Application of Joseph and Alexis Curro

23 North Ward Avenue

Denial Memorandum

Response Letter Block 80, Lot 11; 23 North Ward Avenue

PLOT PLAN

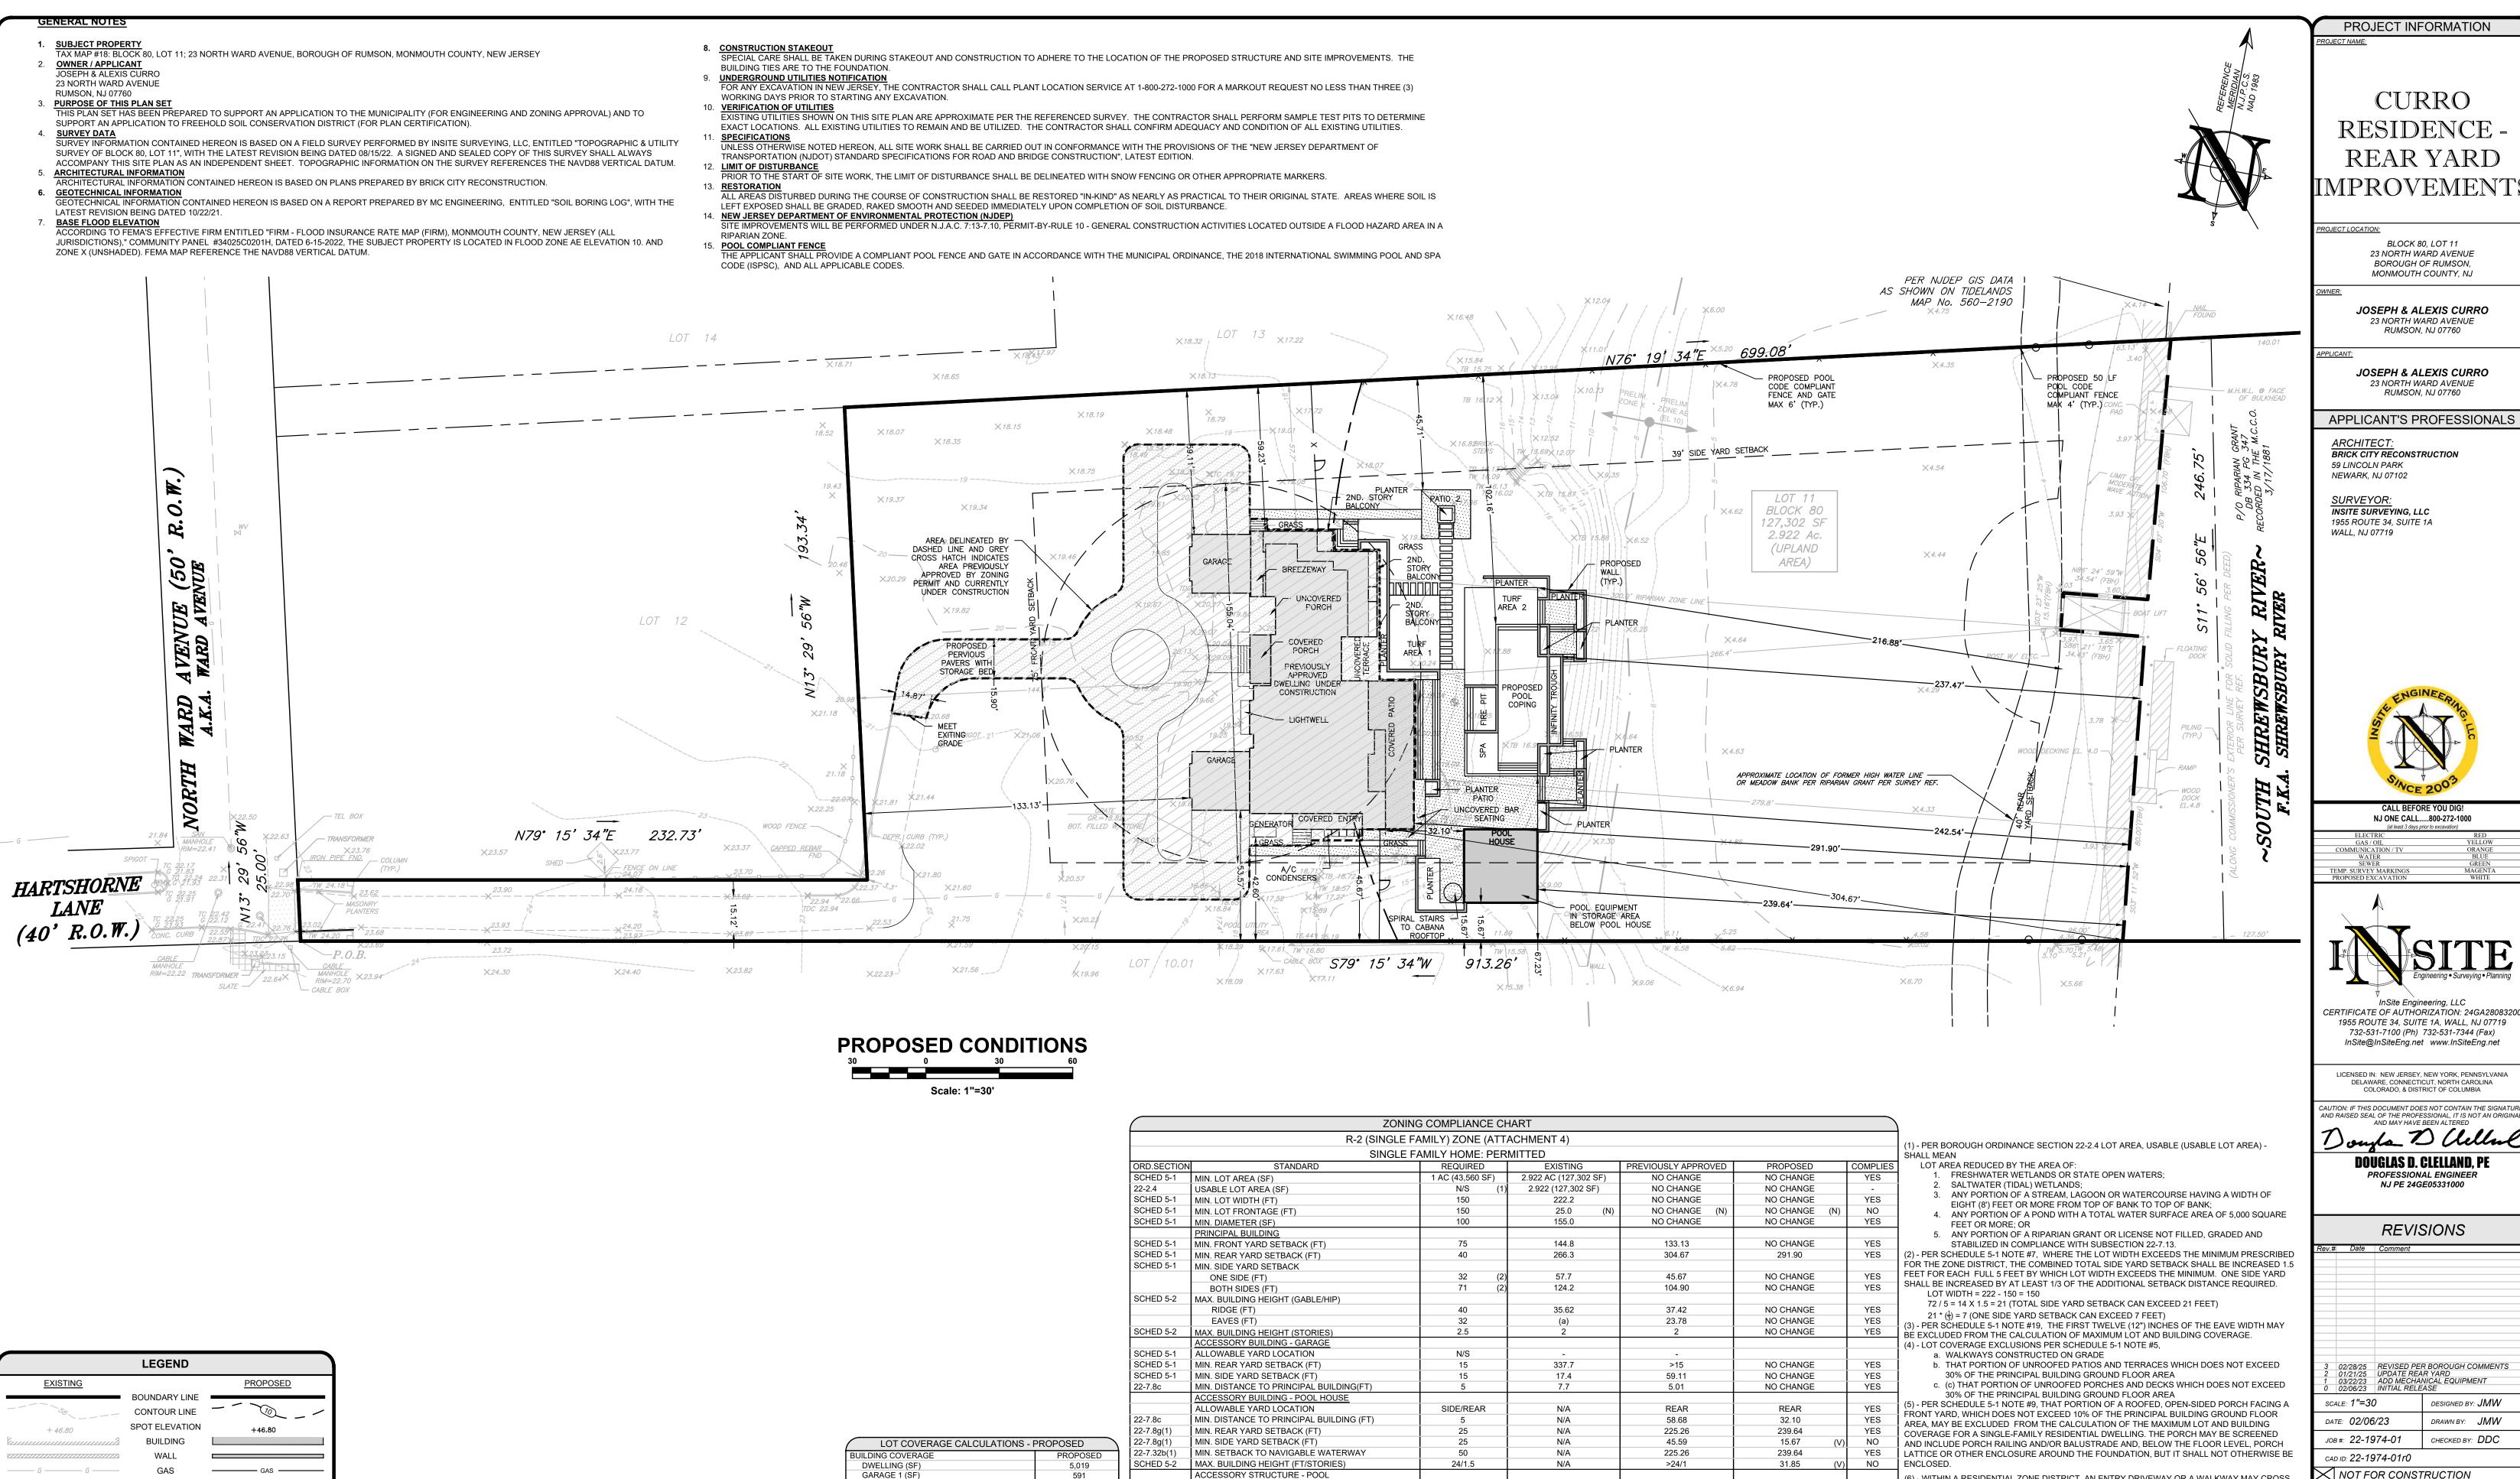
- 1. The Zoning Chart on the Insite plans has a note stating that the Floor Area was not made available to their office. Brick City Remodelers are listed on the Insite Plans as a co-Professional on this project. Please reach out to them and add the pool house floor area to the total.

- 3. The Zoning Chart on the Insite plans has a note stating that the pool house building height is based on the four corners of the pool house. Based on Borough definitions, the building height means the vertical dimension measured to the highest point of a building from the lowest original lot grade or any revised lot grade shown on a site plan approved by the Planning or Zoning Board.

- 4. The Zoning Chart shows a proposed reduction in the front yard setback. Although it is still conforming, please clarify where this change is taking place.

- 5. The total patio area of 4710 SF has been reduced by 1553 SF, representing 30% of the PBGFA (5,177 SF?). The principal building ground floor area remains unchanged on this project and, per the approved Zoning Plans for the NSFH Zoning drawings by Brick City Reconstruction in 2023 is equal to 4,310 SF. This will increase lot coverage and the amount of relief required to be requested.

- 6. Insite lot coverage calculations appear to deduct the front porch twice and at different amounts on sheet 2 of 6 (168 SF and 232 SF).
 - 7. The Zoning Chart requires the following modifications:

- a. Usable lot area left blank.
 - b. The proposed rear yard setback is to the existing attached covered patio and then the proposed pool house (22-7.8).

The Zoning Chart has been revised to include a column for the previously approved zoning application. The pool house floor area is included in the maximum permitted floor area total.

The pool house building height has been revised to be measured from the lowest original lot grade located along the bulkhead.

The Zoning Chart has been revised to include a column for the previously approved zoning application. The front yard setback has not been reduced from the previously approved application.

The zoning chart has been revised to include a column for the previously approved zoning application. The floor area of the two garages was not included in the ground floor area on the previous application. The current application includes the garages in the ground floor area calculation.

The different totals represent the uncovered portion of the front porch and the covered portion of the front porch. The area of a covered porch can be deducted up to 10% of the principal building ground floor area. The area of an uncovered porch can be dedicated up to 30% of the principal ground floor area. Covered porches and uncovered porches are listed in different areas of the zoning schedule.

The usable lot area has been provided in the zoning chart.

The zoning chart has been updated to measure the house setback to the covered patio. The ordinance reference has been revised for the proposed pool house.

POOL HOUSE PLANS

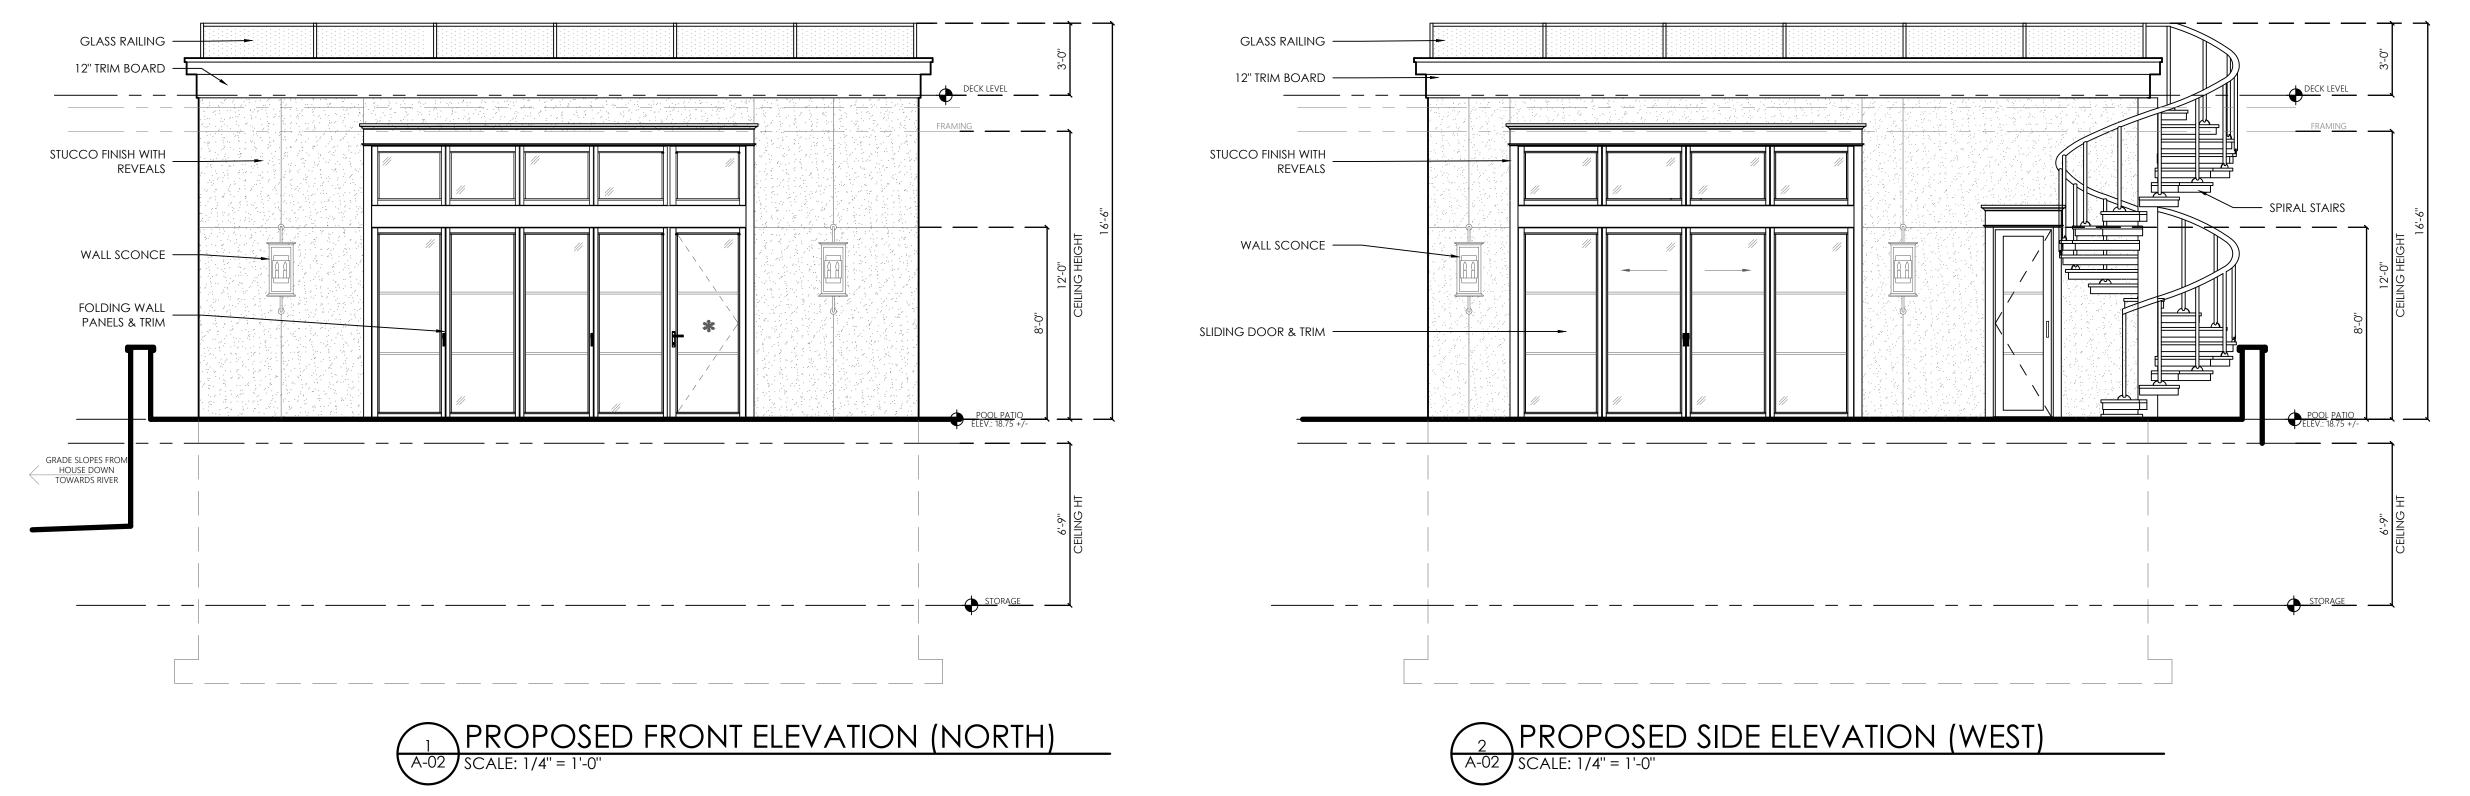
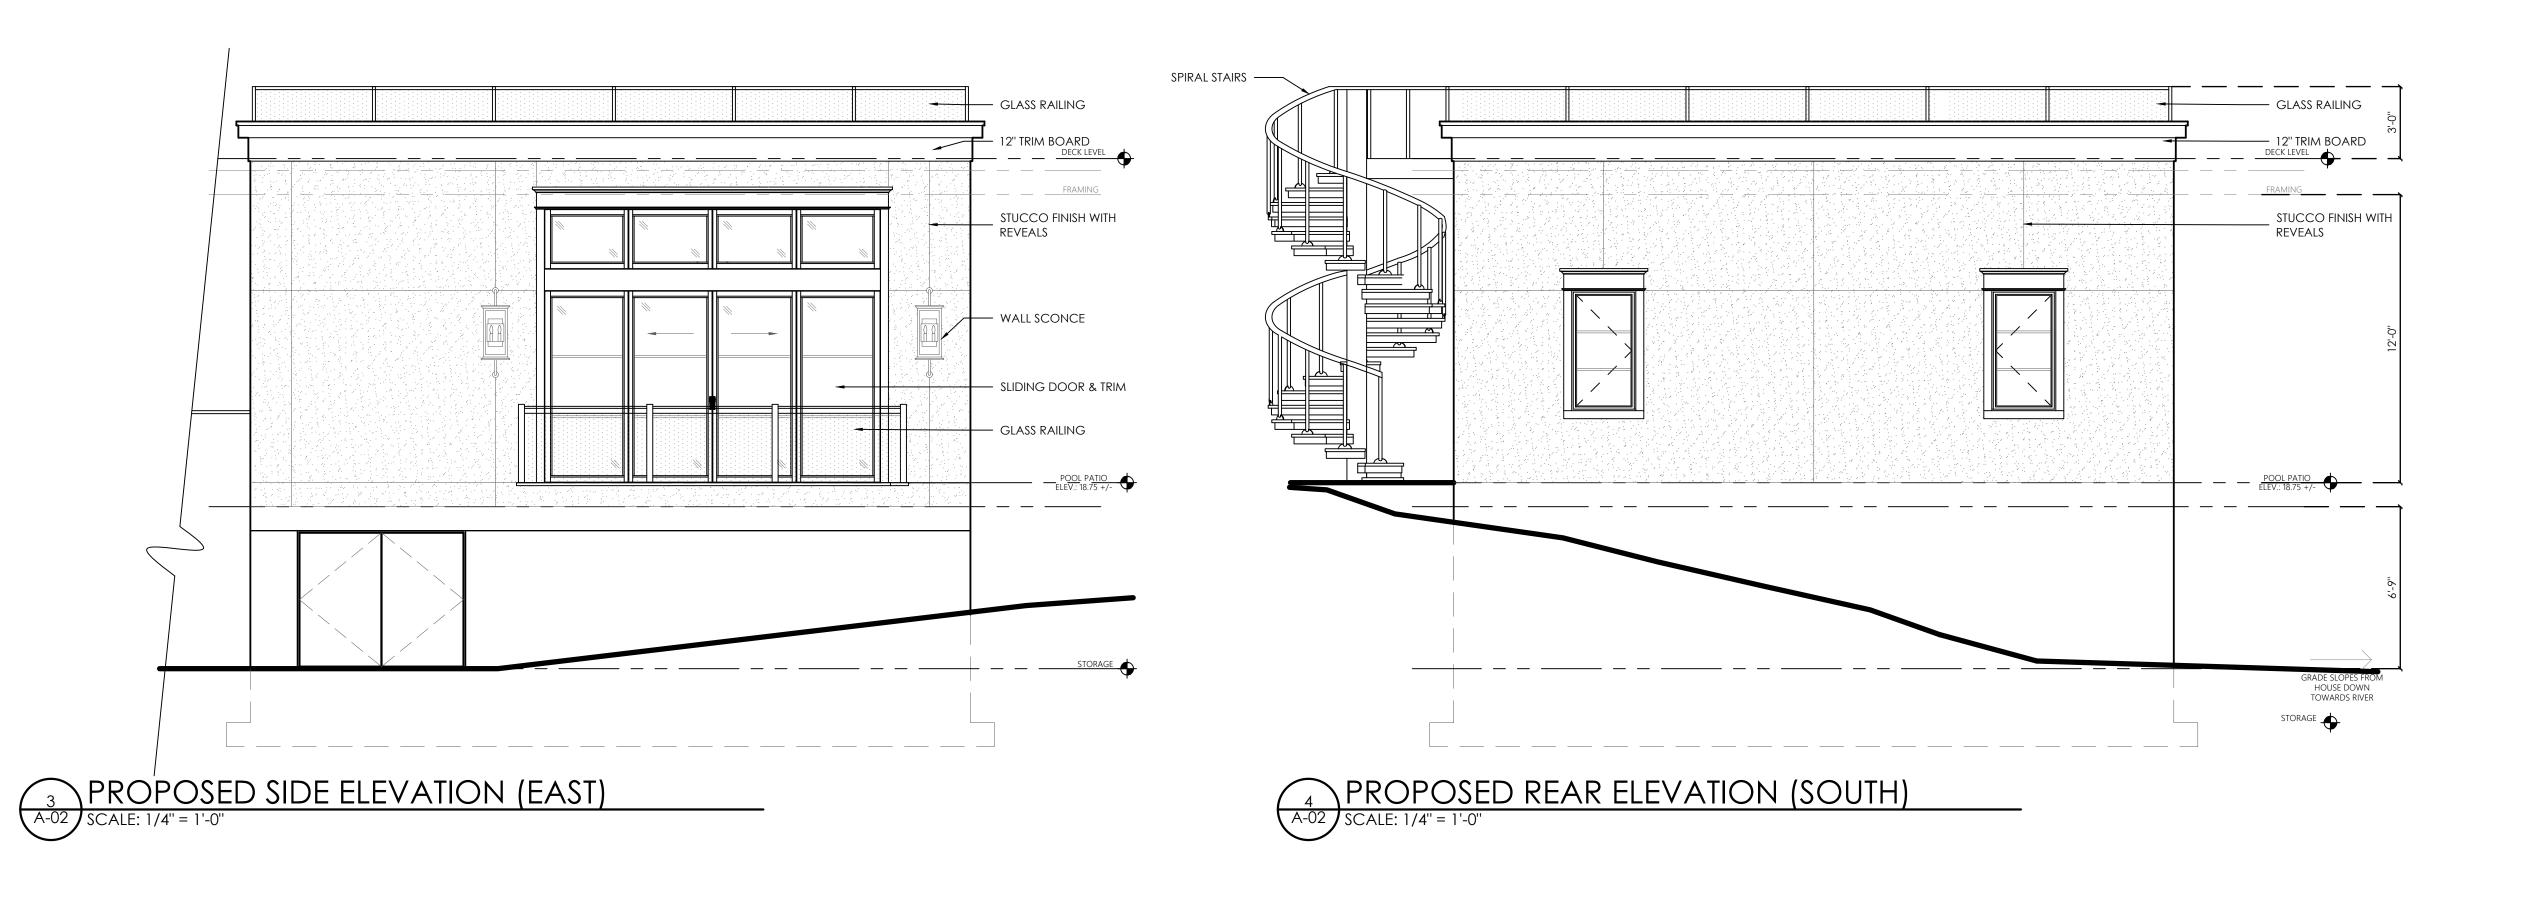
- 2. Pool House Elevations, sheet A-02.00 does not show the proposed overall dimensions from basement floor to top of glass railing on deck above the pool house.

2. Pool House Elevations, sheet A-02.00 does not show the proposed overall dimensions from the basement floor to top of glass railing on deck above the pool house.

Revised architectural plans are included with this submission.
